2 Type of change

Change of approval and rating markings on the moulding body.

Product Change Notification						5091 Change of inscription			
owner	creation date	release date	released by	change order no	rev	page	D40 026 602		
sariogar	15.05.2019	17.10.2019	blumhe	2018584	Α	1 of 2	D10-036-693

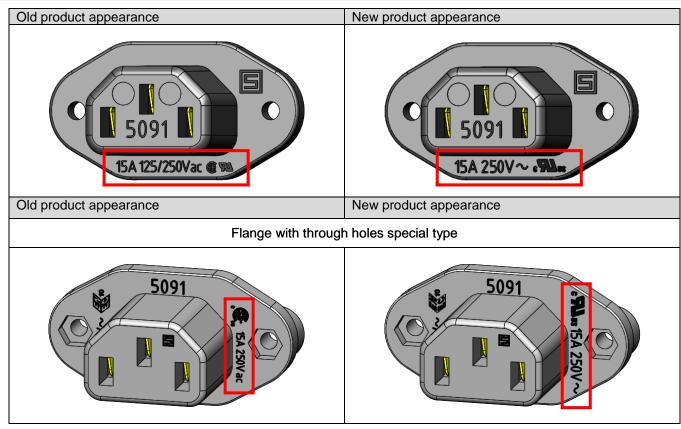
Please note that only rivet-on mounting types and special type are illustrated. However, the same changes apply to both mounting types with screw flange as listed in the affected part numbers list in chapter 1.

Standards update according to the new UL/CSA 60320-1
